# ADDENDUM 03

<b>TO</b>	All Plan Holders	<b>ISSUE DATE</b>	23 November 2022
		<b>PROJECT #</b>	17-006.12
<b>REGARDING</b>	<b>Reroof &amp; Mechanical, Exterior Painting, Window Replacement at Mission Hill Middle School</b>	<b>NARRATIVE PAGES</b>	1
		<b>SPECIFICATION PAGES</b>	0
<b>DISTRICT</b>	Santa Cruz City Schools District	<b>DRAWING SHEETS</b>	3
		<b>TOTAL PAGES</b>	4

Build **AD3-MP1**

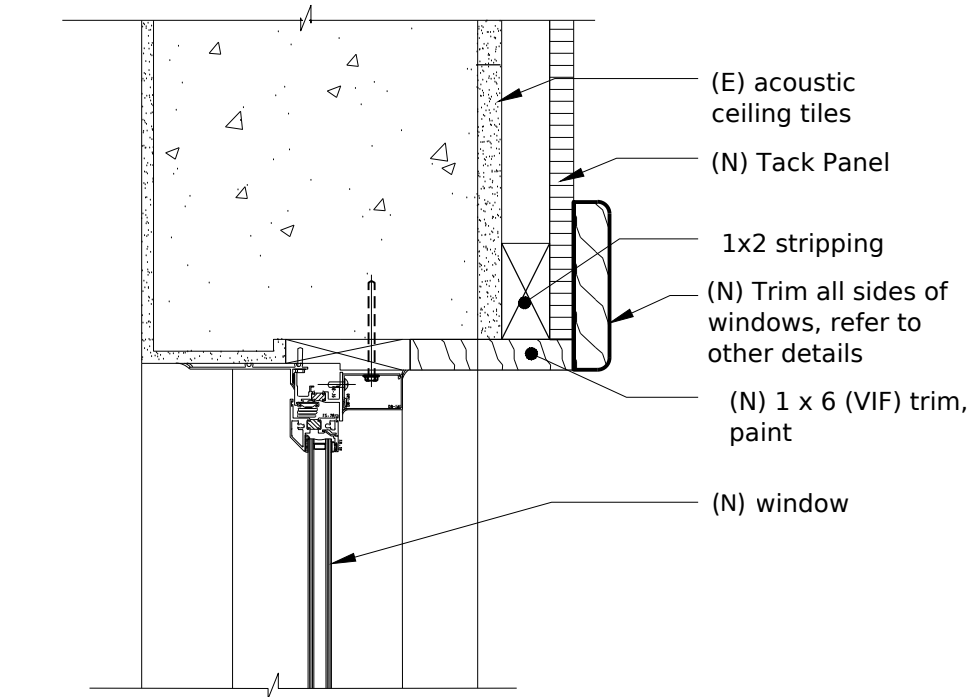
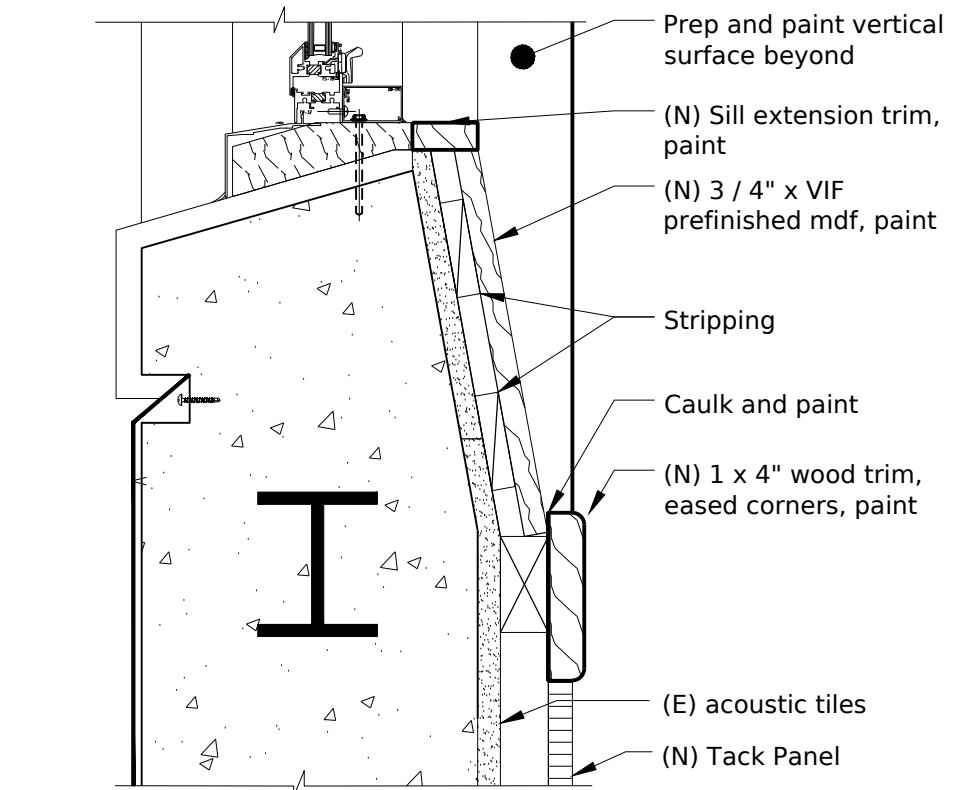
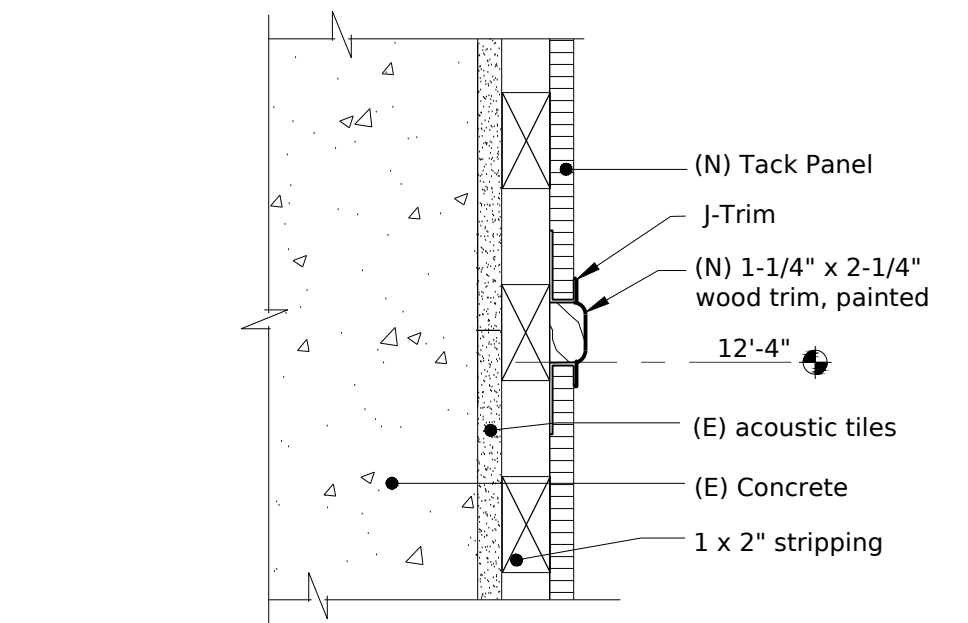
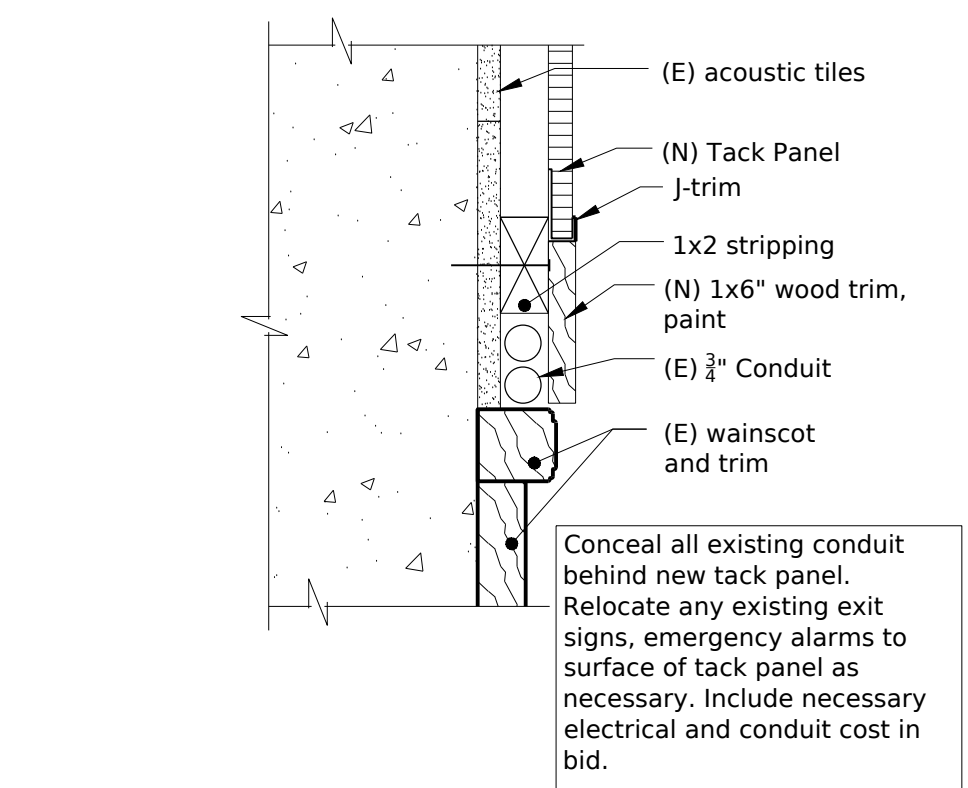
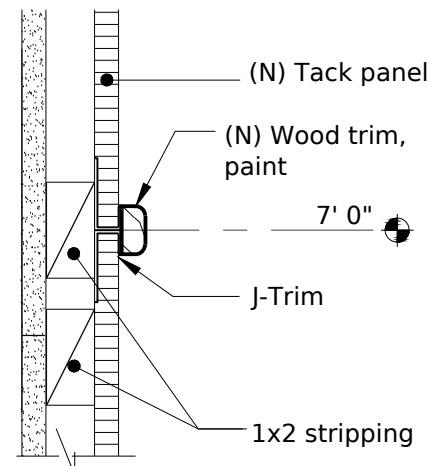
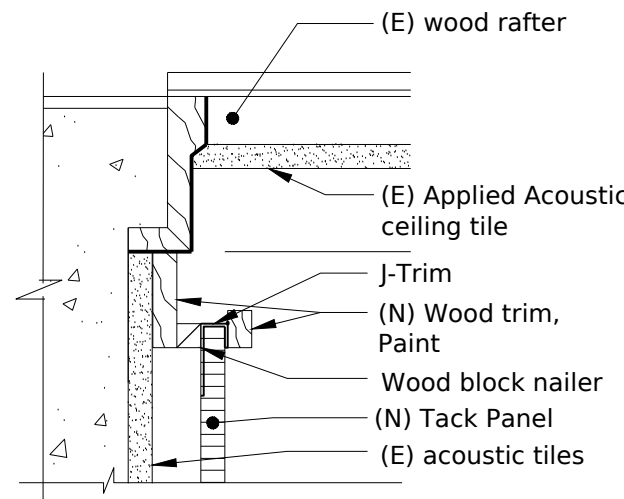
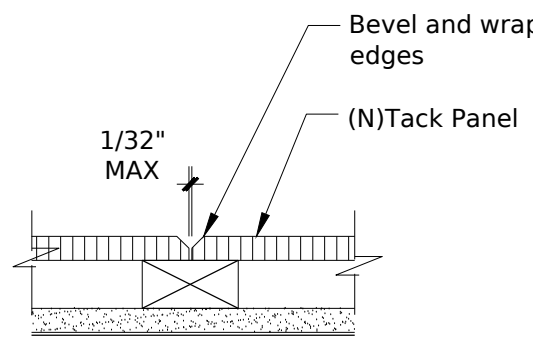
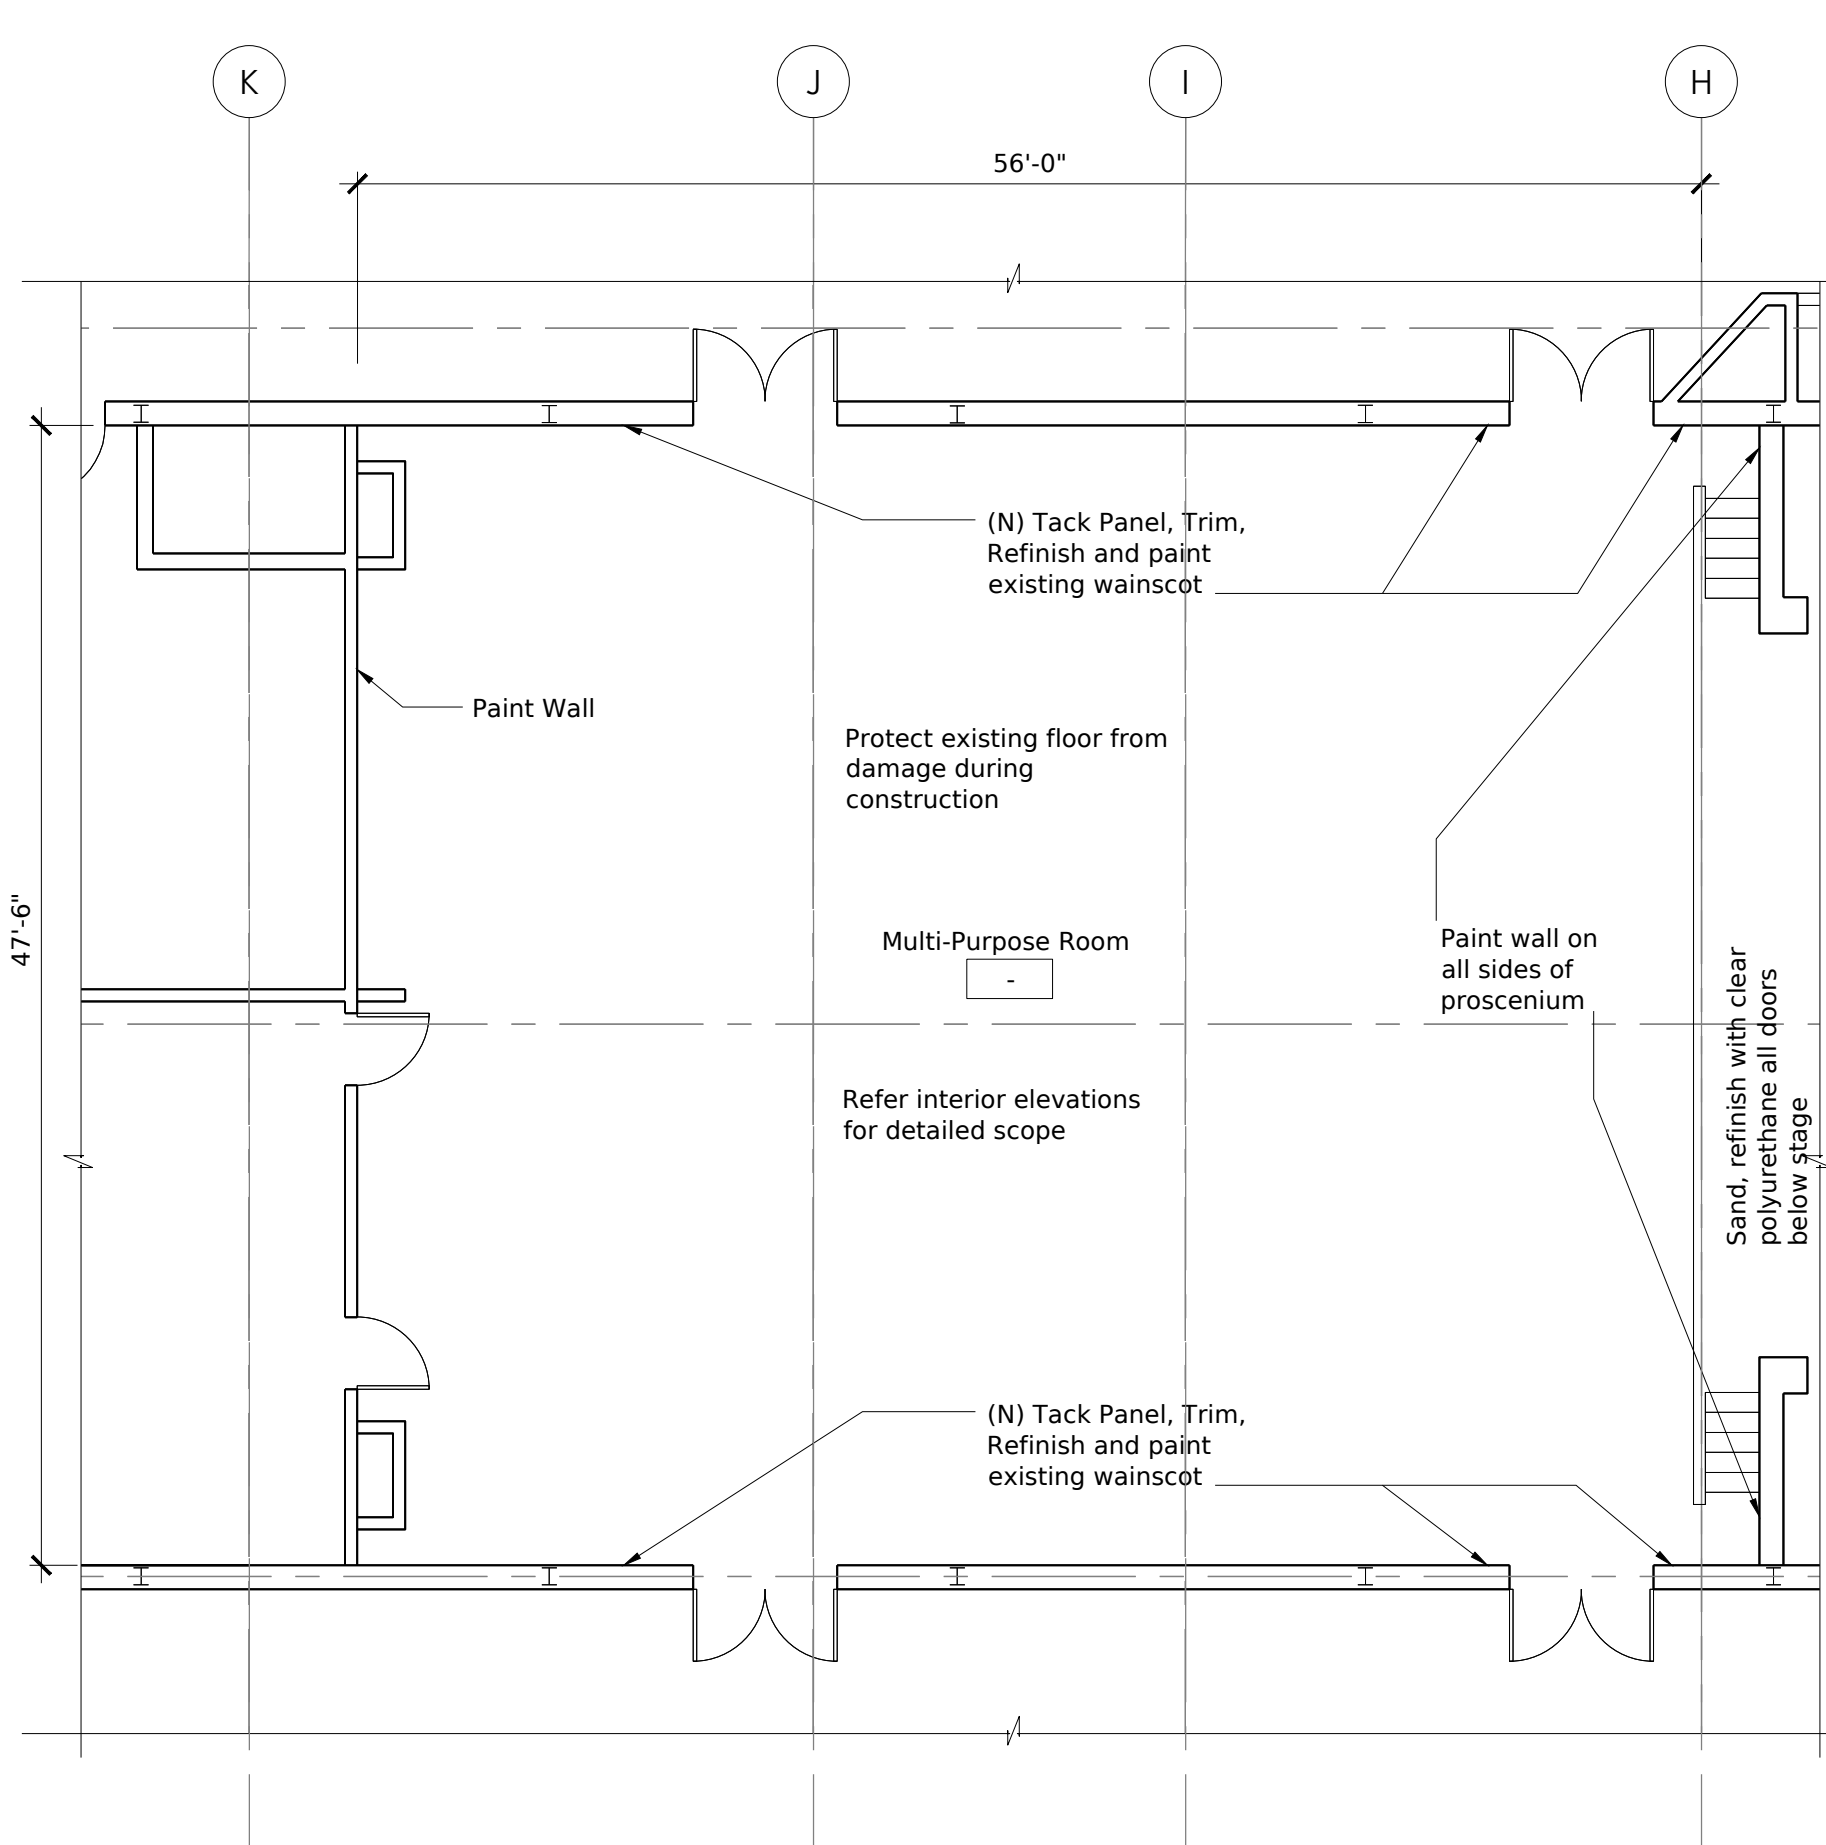
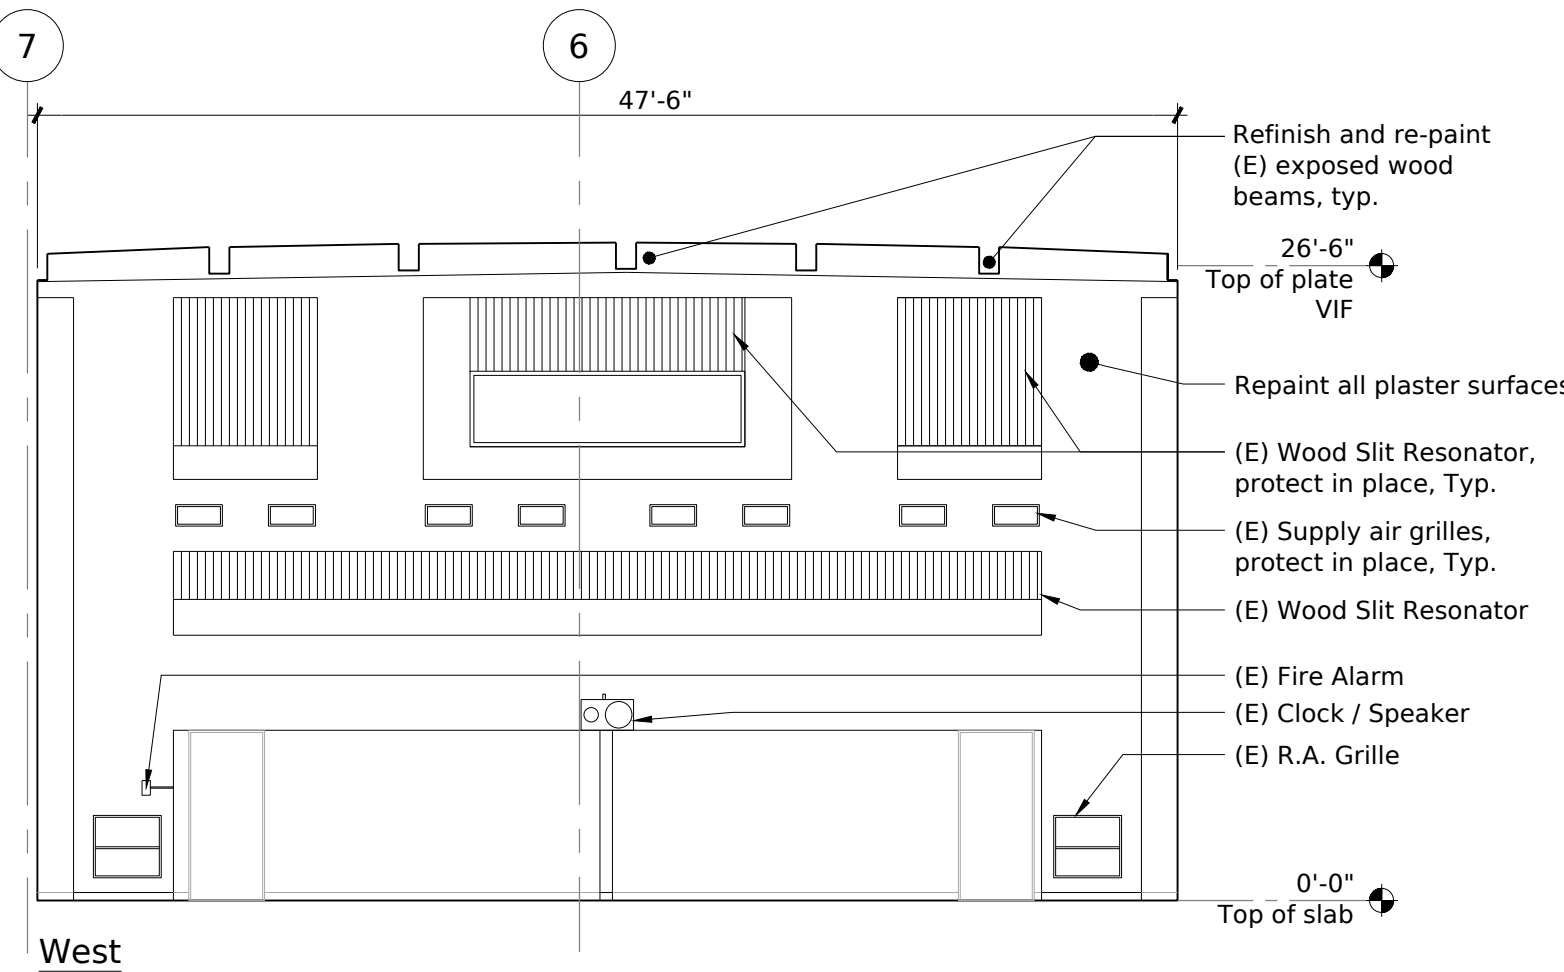
- 05** **AD2-MP1** • **Clarification** of scope of interior improvements at Auditorium. (multi-purpose room)
- AD2-MP-REF** • Refer also to addendum 01 for additional information related to scope at auditorium that still applies
- **Clarification:** Tack panel to be installed over 1x stripping to provide chase and cover all existing electrical conduits
- **Clarification:** Paintable pre-primed finger pine trim at all locations trim is indicated. Paint to match existing wood ceiling beams.
- Reference drawing from 1930 original construction with section and details is provided for reference.
